## **NUCLEAR REGULATORY COMMISSION**

Title: Advisory Committee on Reactor Safeguards  
Digital Instrumentation and Control

Date: Friday, October 22, 2021

## Cyber Security Defensive Architecture

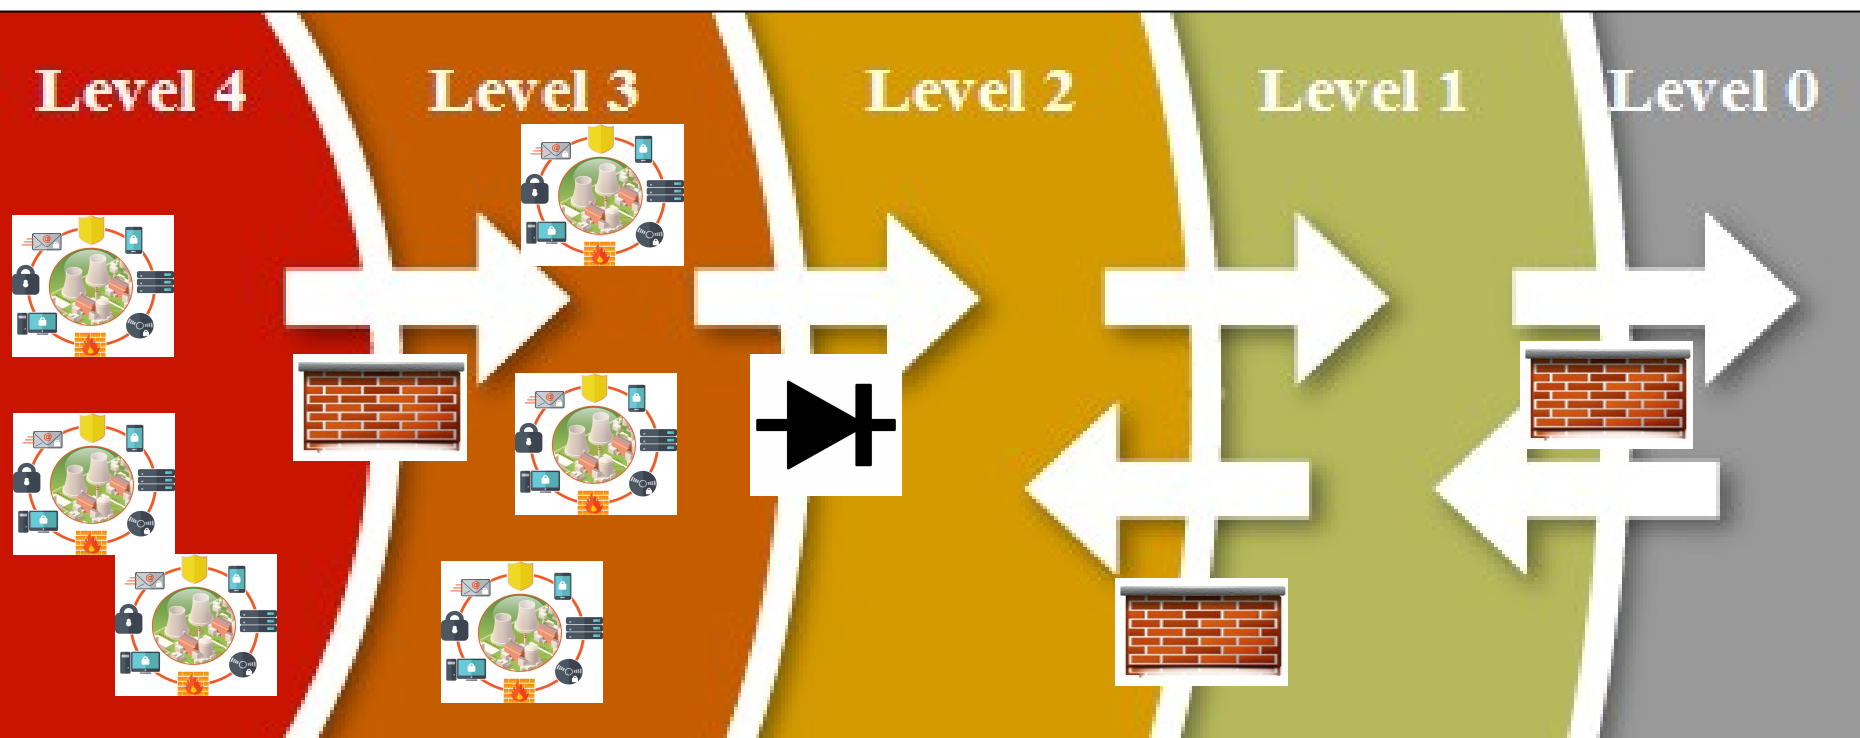
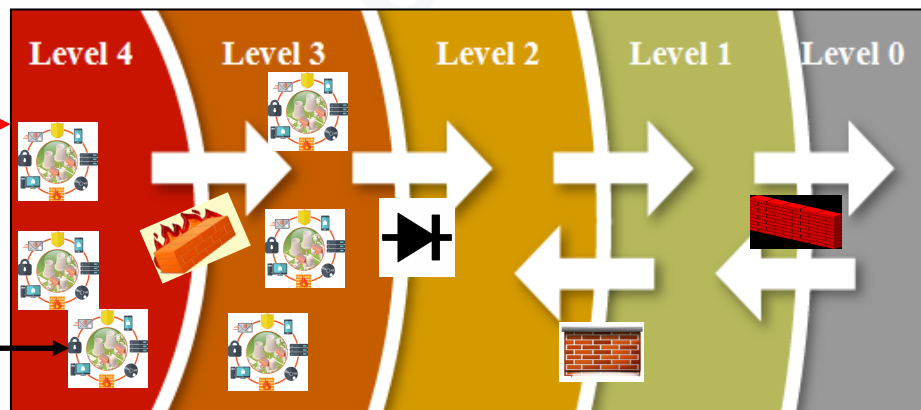
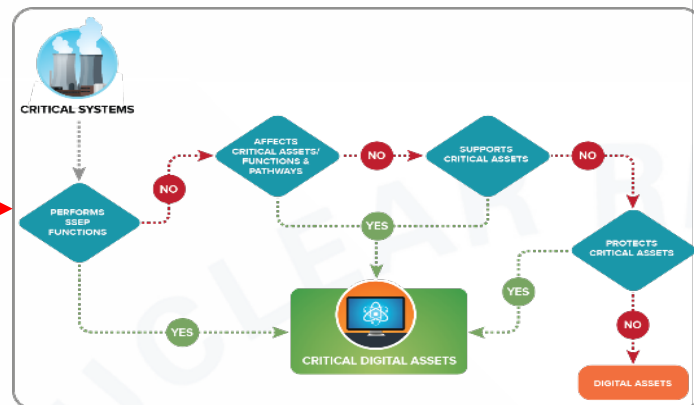
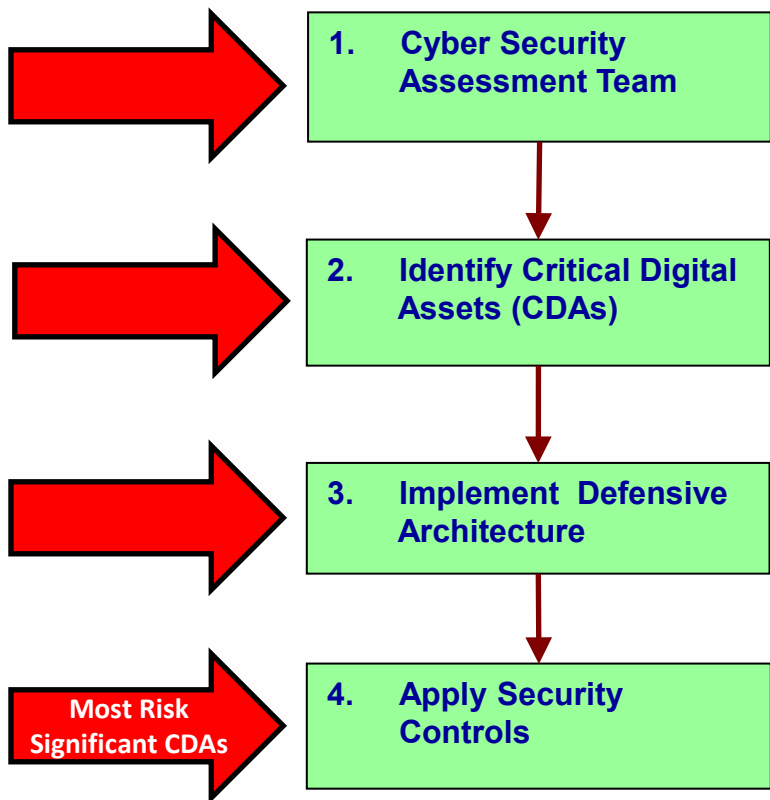
7 CHAIR BROWN: I agree with you, actually,  
8 and there's an interesting change you all made to the  
9 bullets underneath the defensive architecture figure.  
10 I think it's now Figure 5 or 6, I don't remember  
11 which, where I will bring your point that you just  
12 said.

14          MEMBER KIRCHNER: I like that but then if  
15          you look over from Level 4 to Level 3, that network  
16          could have been a Level 3 and you show a firewall.  
17          And a firewall is a bi-directional software-controlled  
18          data transmission device.

11 And this was in the preamble part of 3.2,  
12 the input part. One of the paragraphs talks about,  
13 and it says, while a data diode can be an important  
14 element of an acceptable defensive architecture, use  
15 of a data diode alone does not provide adequate  
16 protection to comply with the defense in-depth  
17 strategies required by 73.54.

9 But, I'm aggravated. Not aggravated,  
10 that's the wrong word. I was a little concerned that  
11 the message comes out that the data diode is the new  
12 thing that has come in here to provide a protection  
13 that we did not have now with the electronic.

1           So, not alone but the firewall with the  
2           data diode is used to provide the defense in-depth.

1       that, which is why firewalls are also used, in  
2       conjunction with the correct placement of a data  
3       diode. It would not be an adequate implementation to  
4       have only firewalls.
